RE: Dowe Flats Quarry, Permit No. M-1993-041 – Technical Revision #5  
Reclamation Plan Revisions

Exhibit 1: TR-05 Reclamation Plan Revisions

**Exhibit 1: Parcel to be Purchased by Boulder County Parks & Open Space with Proposed Changes to the Dowe Flats Reclamation Plan**

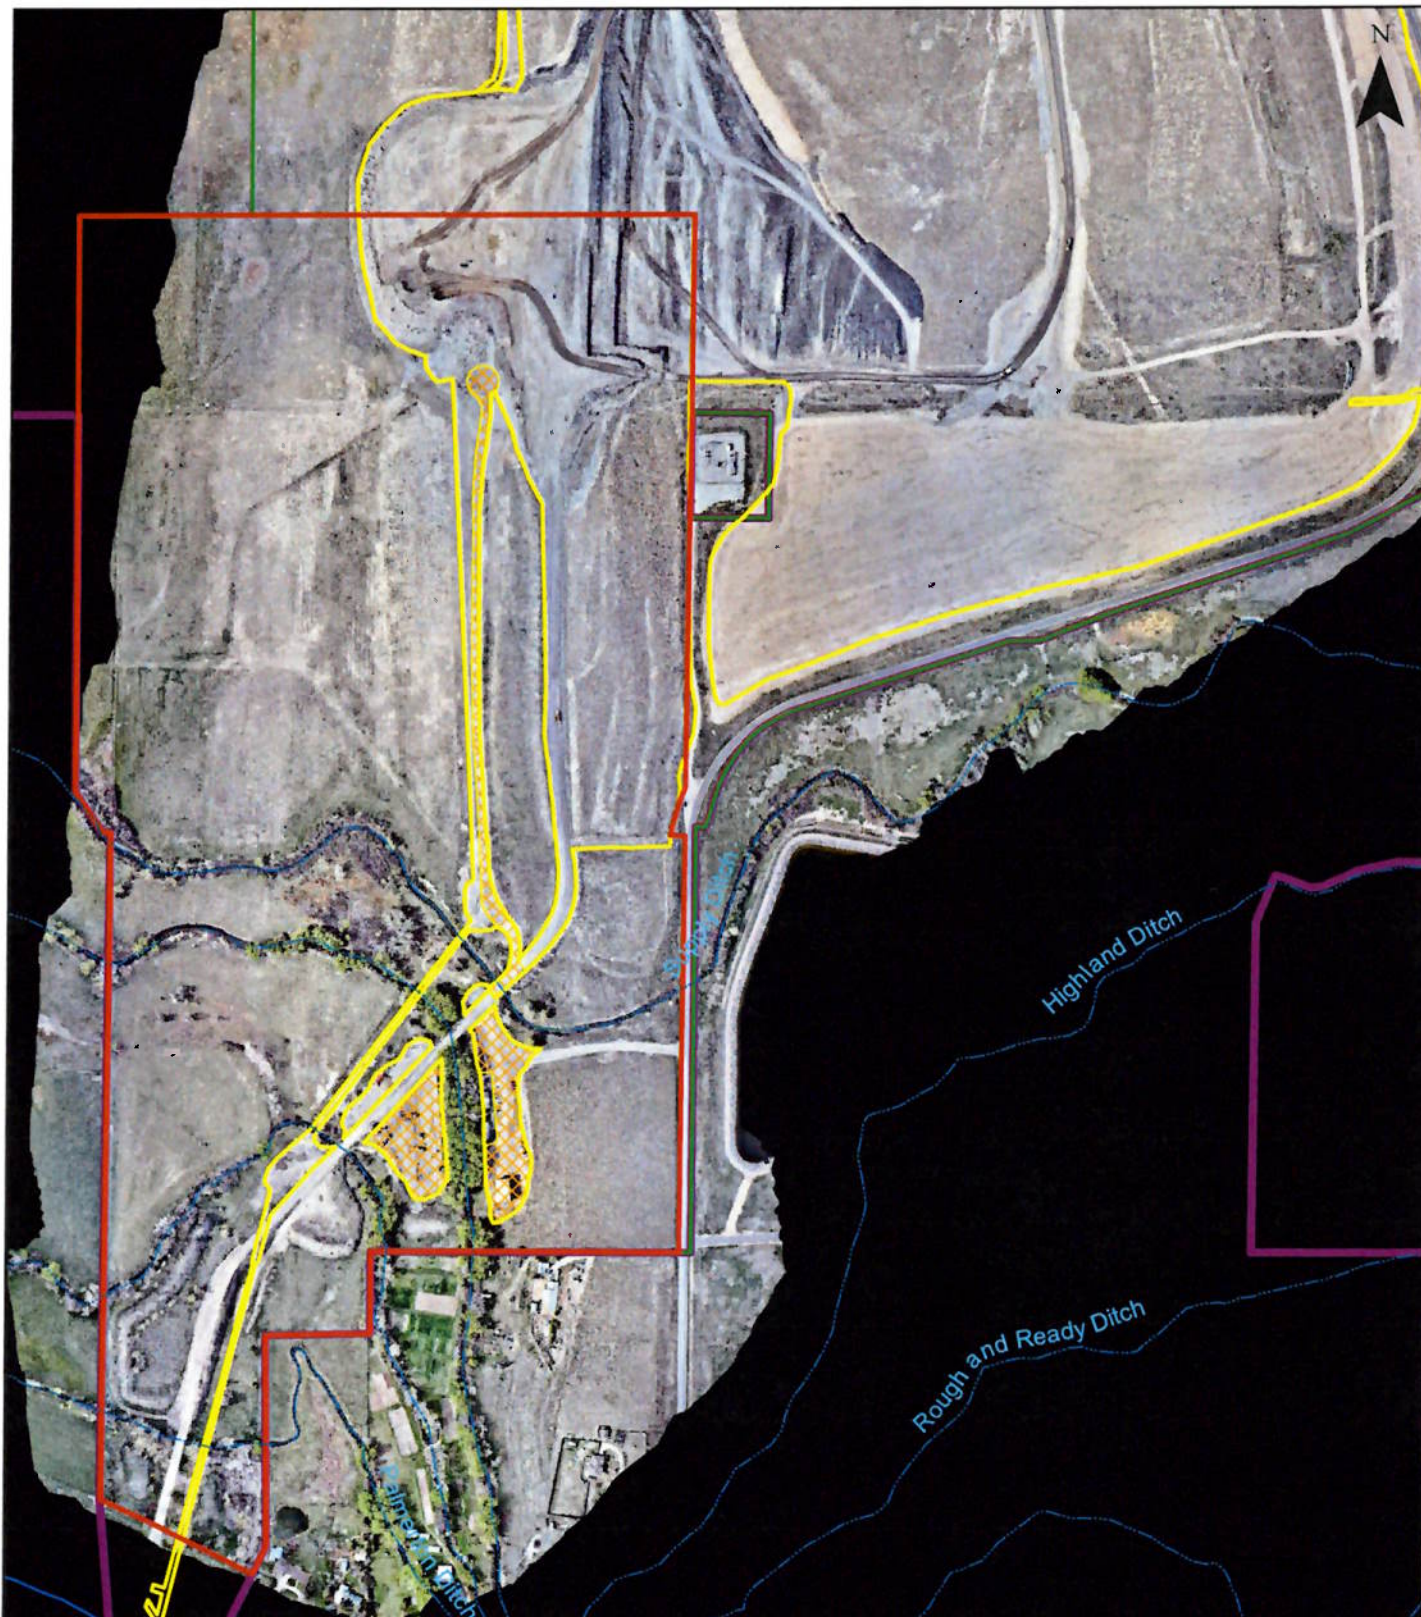
Boulder County Parks and Open Space (BCPOS) has exercised an option to purchase the southern portion of Cemex's Dowe Flats Quarry property (Exhibit 1) once reclamation is completed. BCPOS has requested that several of the current improvements on that portion of the property be retained during and after final reclamation to support their future planned use of the property after acquisition. A letter from BCPOS in support of this change is attached as Exhibit 2. Cemex and BCPOS both believe that the retention of these items supports the permitted agricultural and/or wildlife habitat post-mining land uses of the quarry property. The improvements to be retained, illustrated on the map to Exhibit 2, include:

In the current reclamation plan, these items would be removed and the areas revegetated to grassland habitat. This change to the reclamation plan results in 4.4 fewer acres of grassland habitat.

**Exhibit 2: Letter of Support from Boulder County Parks & Open Space with Map of Retained Structures & Improvements**

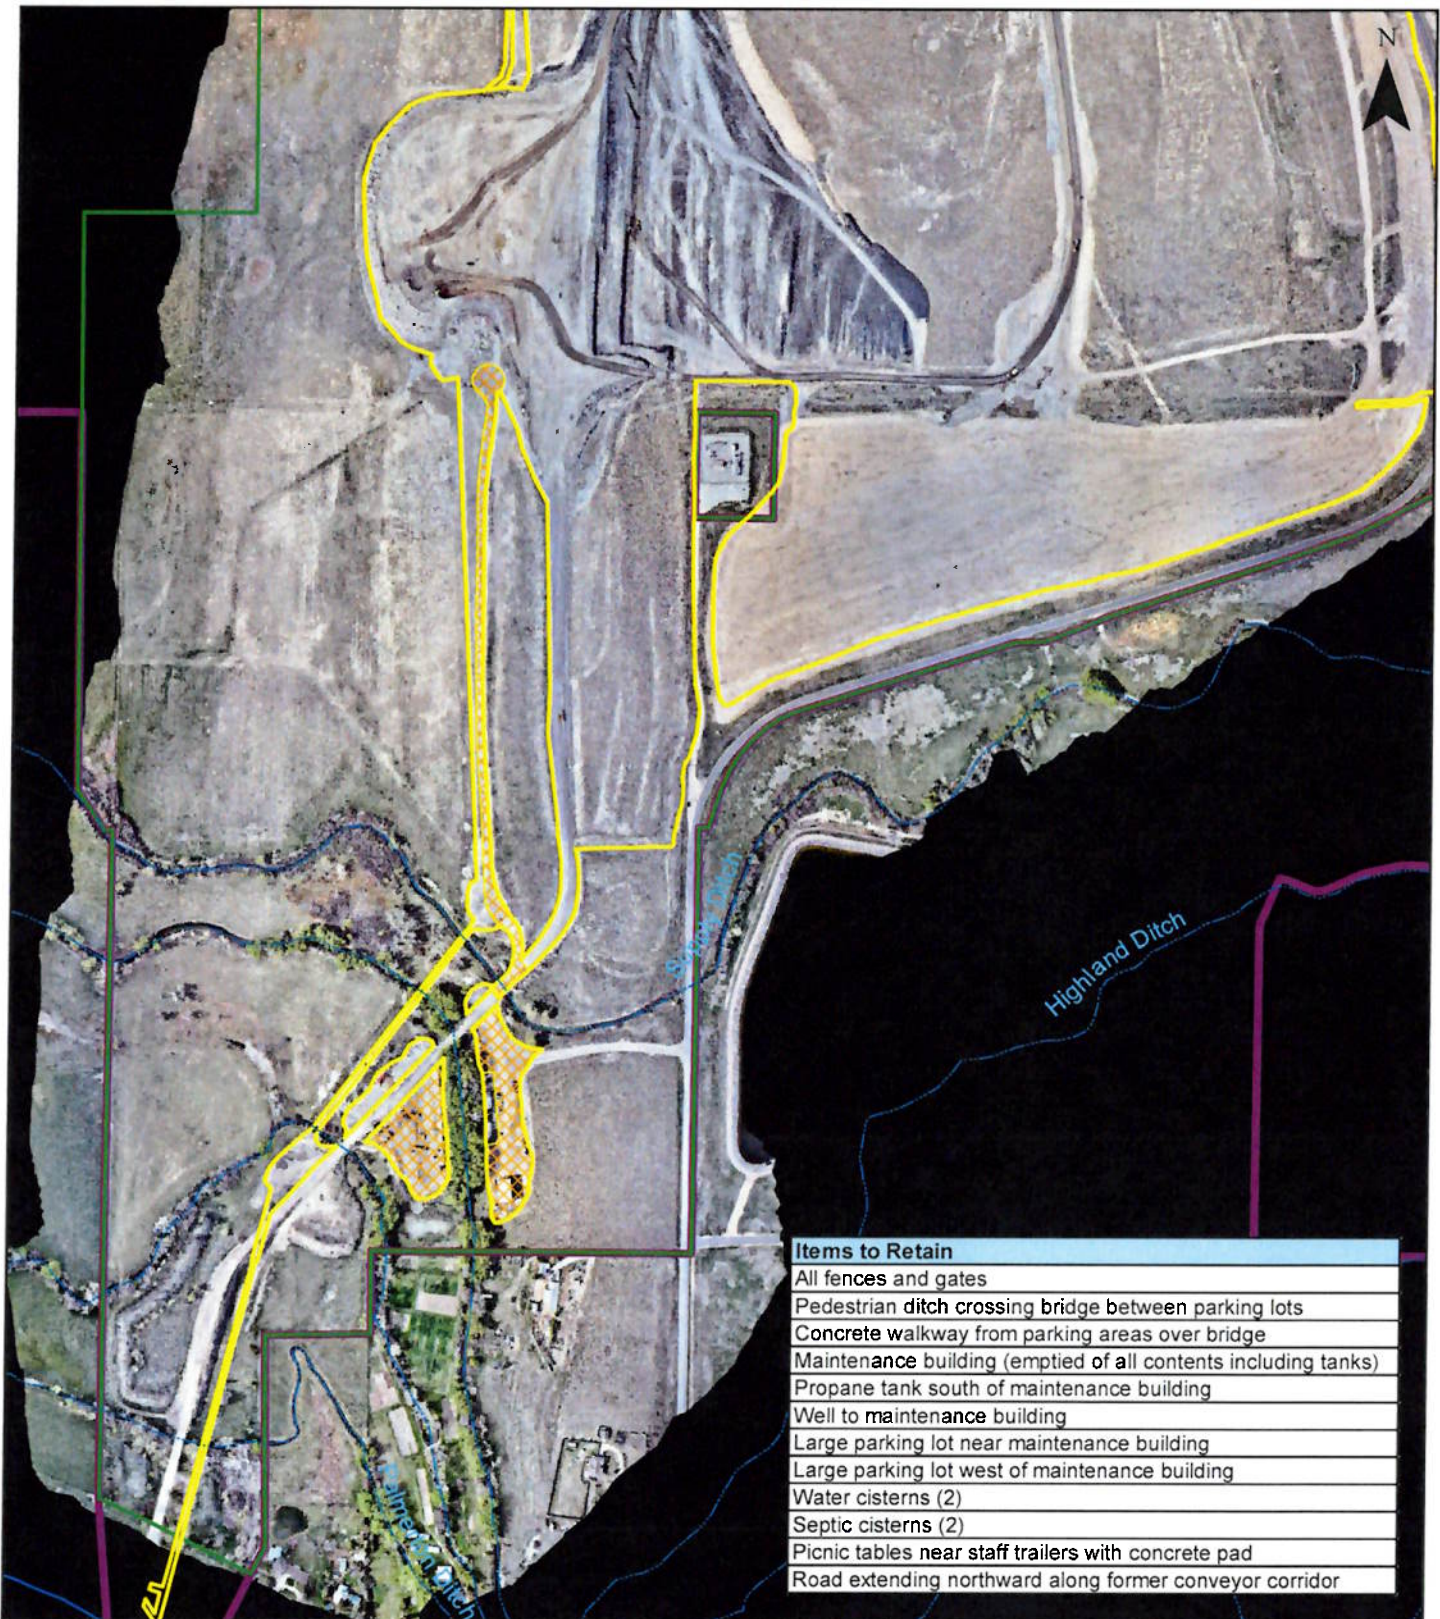
- All fences and gates
- Unpaved parking lot near maintenance building
- Unpaved parking lot west of maintenance building
- Pedestrian ditch crossing bridge between unpaved parking lots
- Concrete walkway from unpaved parking lots over bridge
- Maintenance building (emptied of all contents including tanks)
- Propane tank south of maintenance building
- Well to maintenance building
- Water cisterns (2)
- Septic systems (2)
- Picnic tables near staff trailers with concrete pad (trailers to be removed)
- Dirt road extending northward along former conveyor corridor

CEMEX has agreed to leave the improvements the county has requested if your office approves doing so. I am writing on behalf of Boulder County Parks & Open Space to support revising reclamation requirements so those improvements can remain.
